Enclosure 2. Conforming Amendments to Facility Licenses Nos.: DPR-1, TR-1, R-33, DR-10

THE VALLECITOS BOILING WATER REACTOR

AMENDMENT TO FACILITY LICENSE

Amendment No. 21  
License No. DPR-1

Figure 6-1. Facility Organization

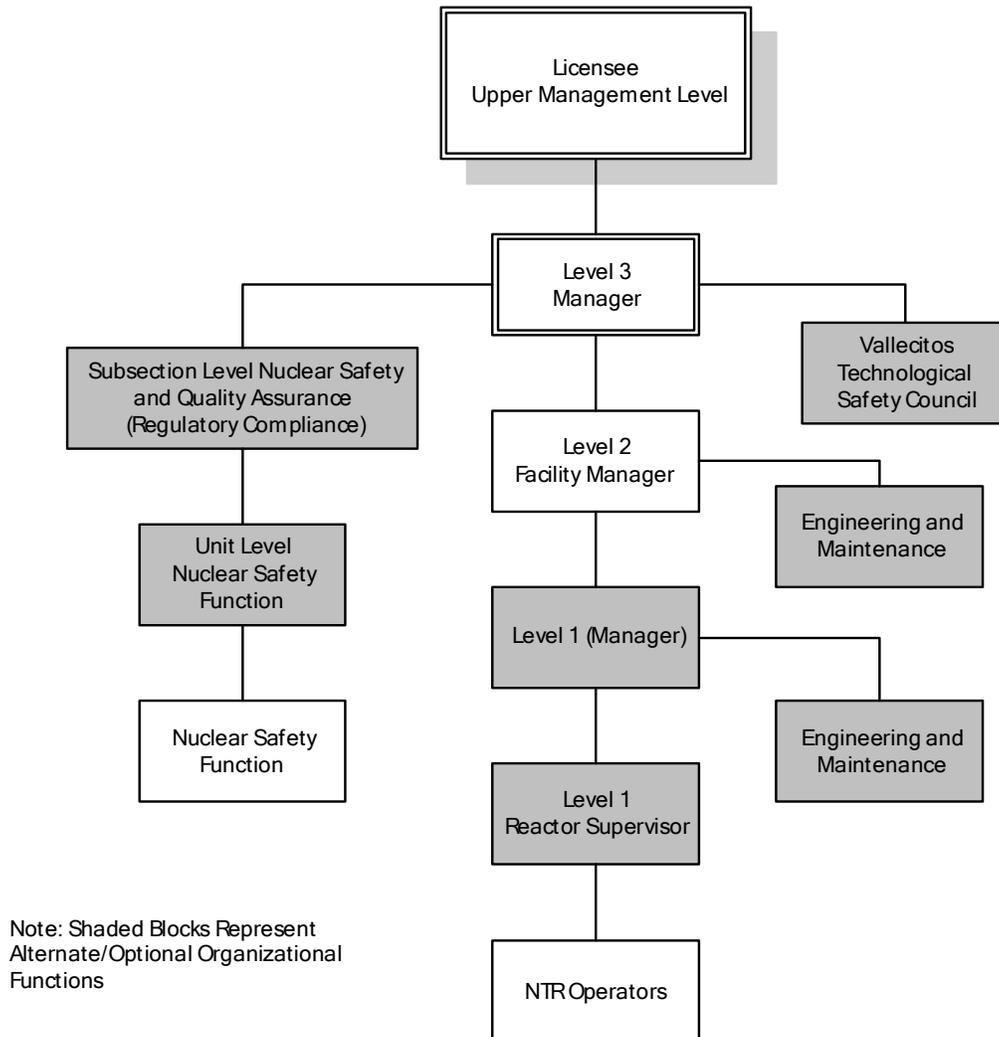
The NTR shall be owned and operated by the licensee with management and operations organization as shown in Figure 6-1 or equivalent. |
